Re: Connecticut Humane Society – Application for Special Permit and Site Plan Review
(SP#480) and Application for Regulation Amendment (REG#21388)
Premises: 863-875 Danbury Road, Wilton, CT

As attorney for Connecticut Humane Society (“CHS”), this letter sets forth our responses to the comments and questions contained in Director Wrinn’s email dated July 30, 2021. In support of those responses, either for reference or because they have been amended, I enclose one (1) copy each of the following:

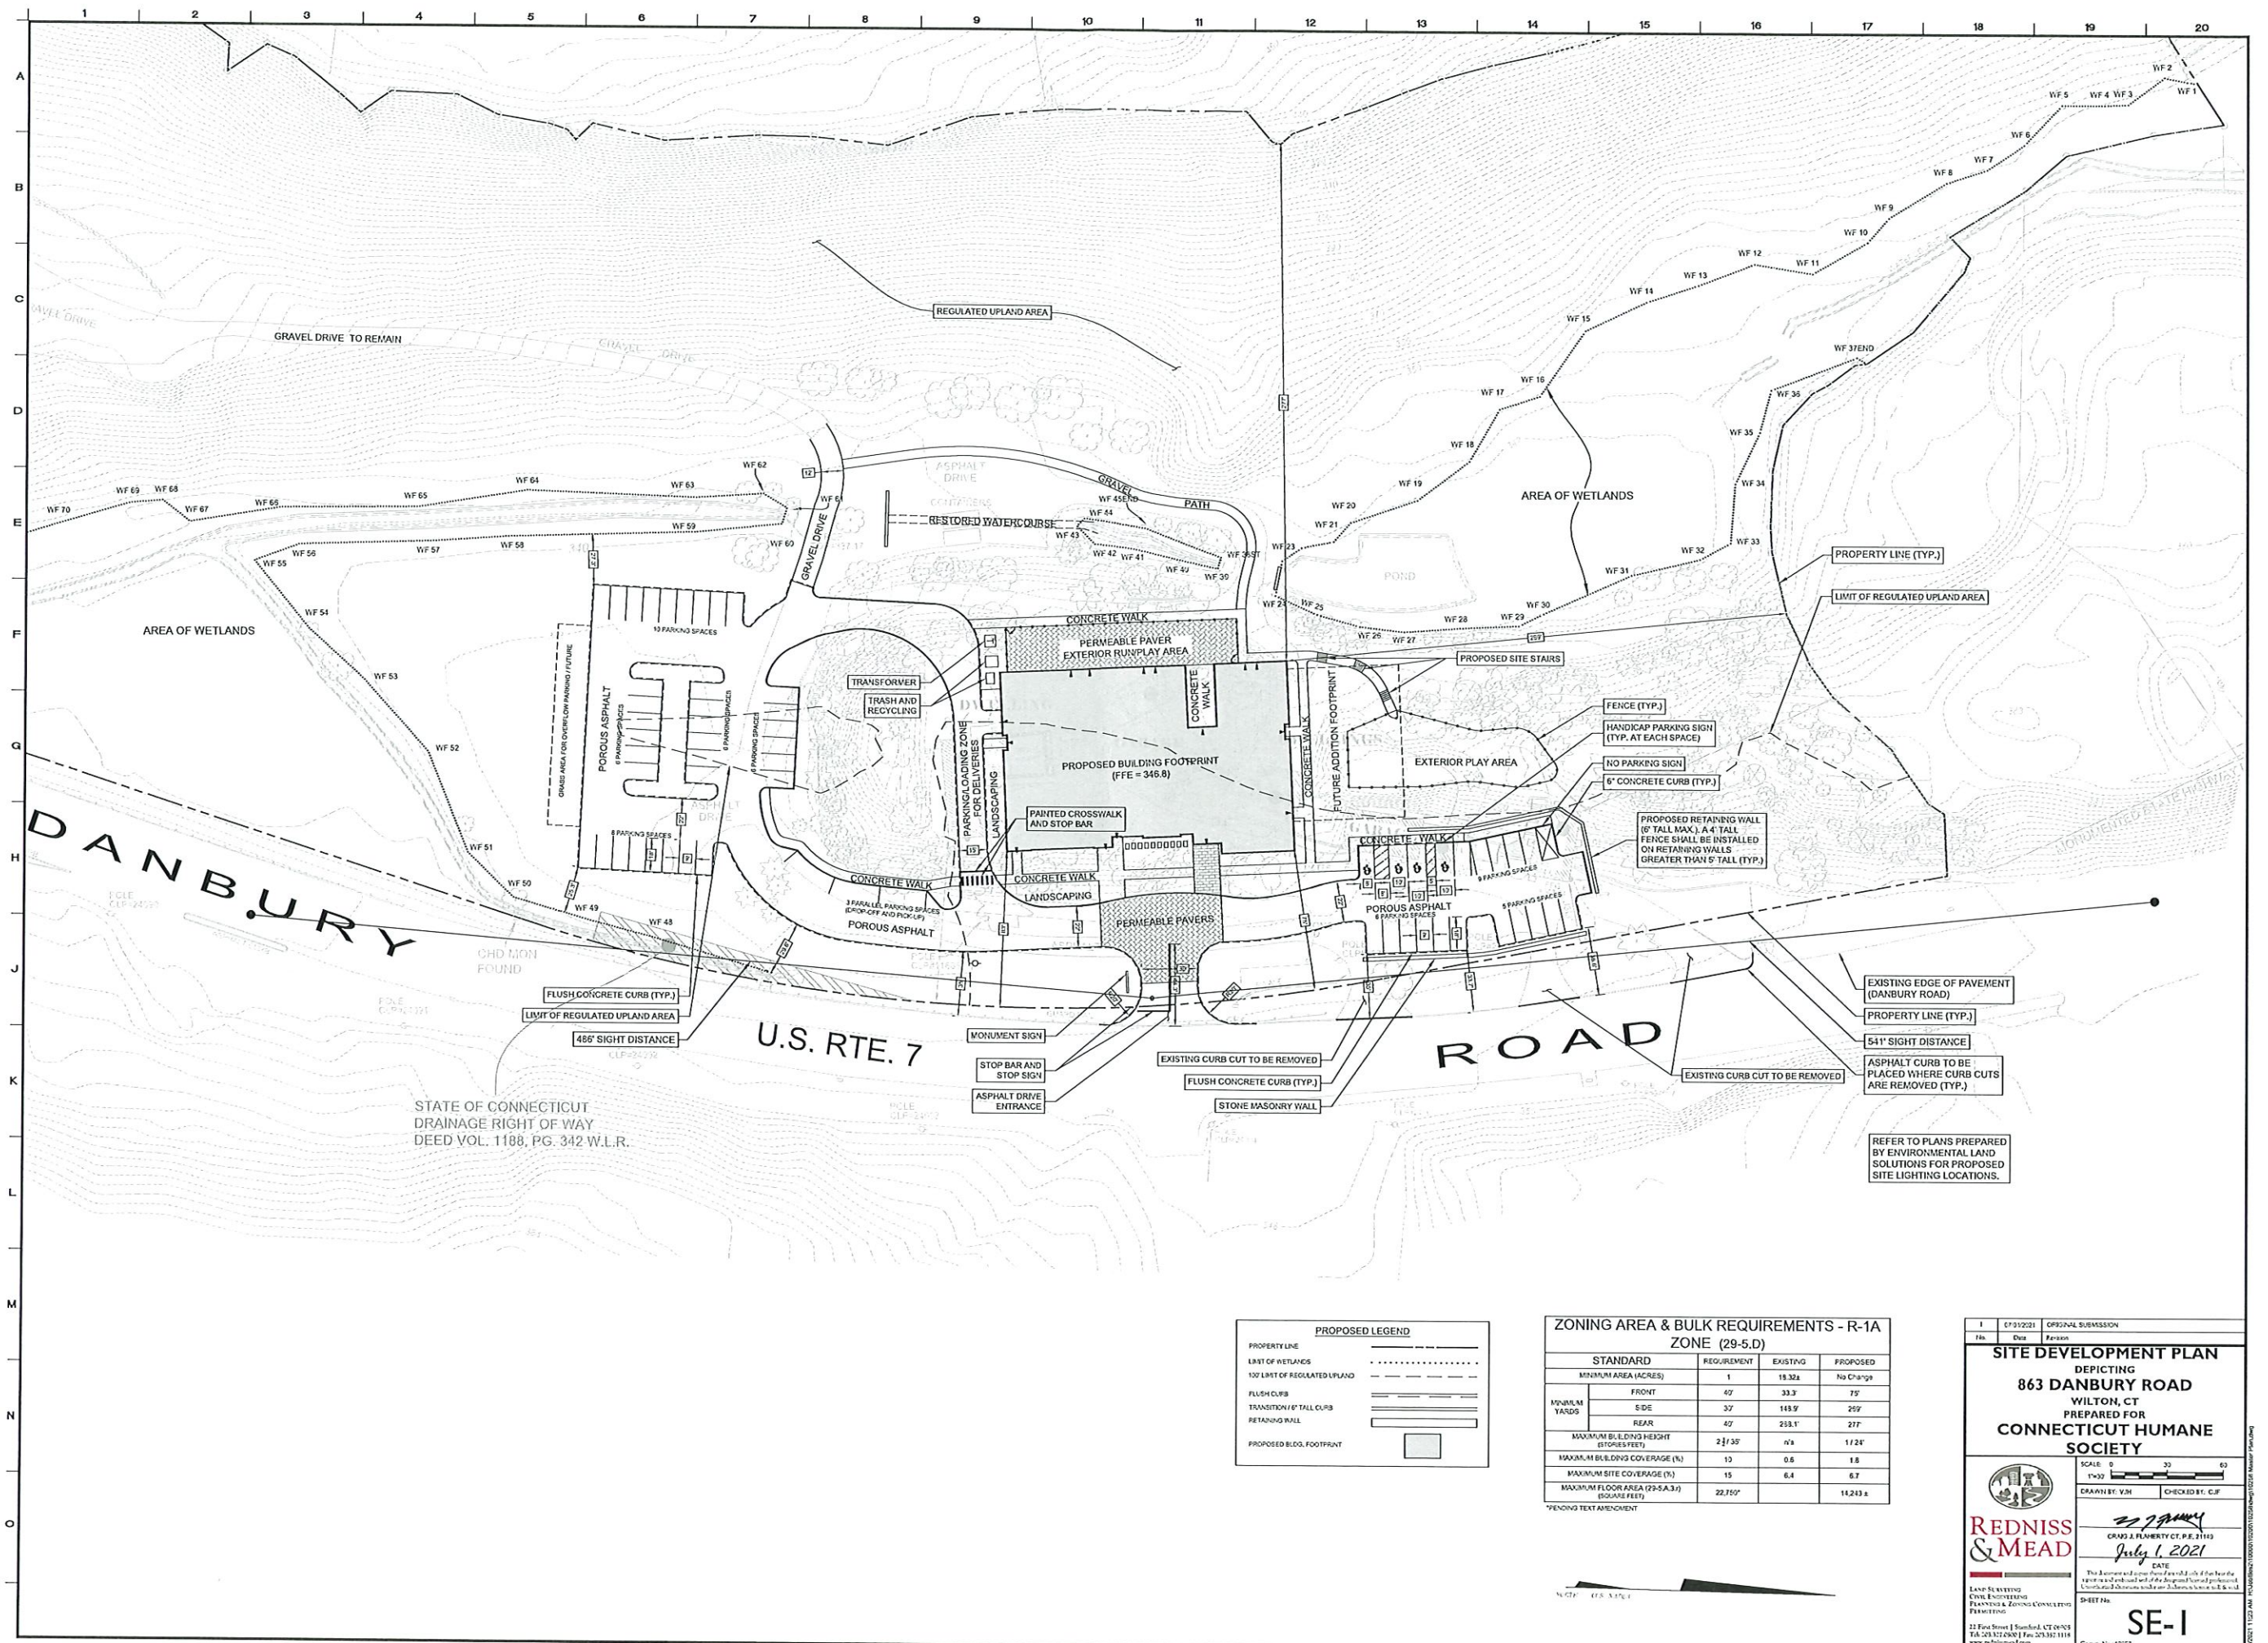
Comment #6: The detail for the wheelchair accessible parking space unloading area note that it is either curbed or striped. It seems that they should either be dropped curbs or striped but not curbed.

Response: *CHS is providing flush curbs as shown on the updated Notes and Details (SE-6), prepared by R&M, dated July 1, 2021, revised August 24, 2021.*

SE-I

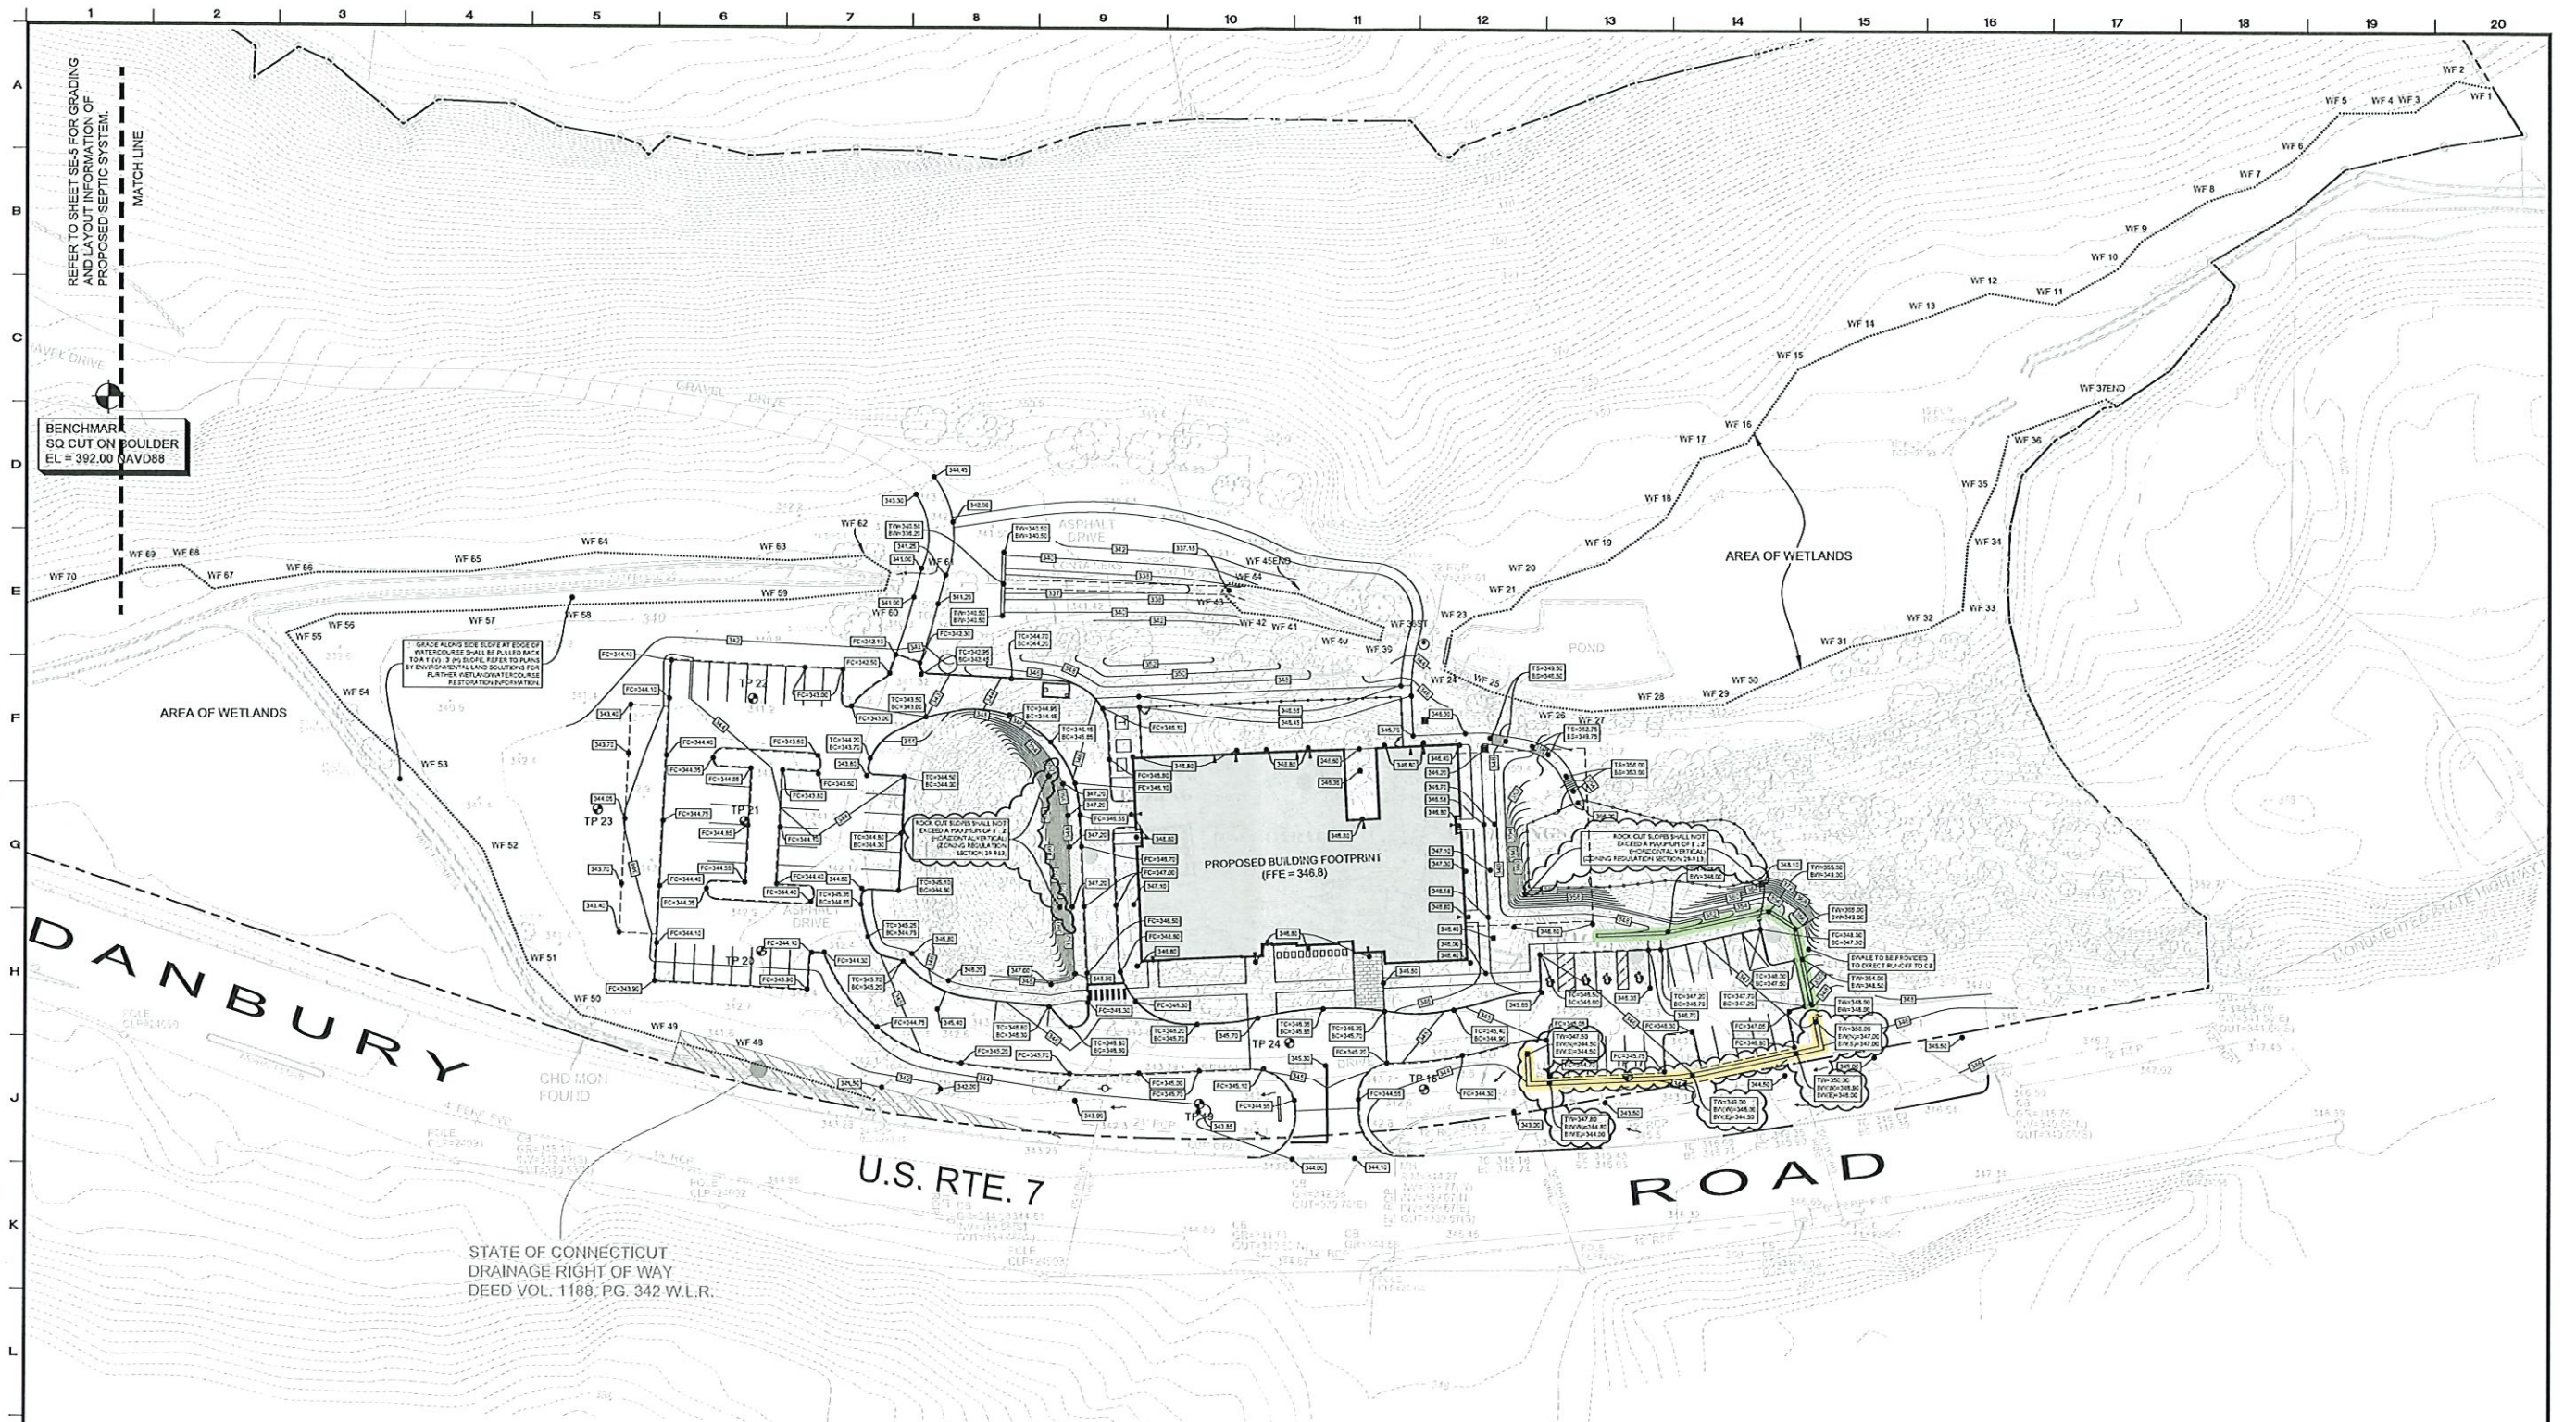
Comment #5: The engineer's plan should note that any retaining wall over 5' in height will have a fence on top at least 4' in height (Section 29-9.I.5).

Comment #10: Will one loading space be needed? Is there one proposed?

Response: *CHS acknowledges this requirement and notes that on SE-1 prepared by Redniss & Mead, dated July 1, 2021, there is a note that states: "Proposed retaining all (6' tall max.). A 4' tall fence shall be installed on retaining walls greater than 5" (typ.)"*

Response: *A parking/loading zone for deliveries, along the south side of the building, is noted on SE-1, prepared by Redniss & Mead, dated July 1, 2021. Given the nature of deliveries to CHS (e.g., pet food and veterinary/clinic supplies) no special loading dock is needed, just access to an ingress and egress door.*
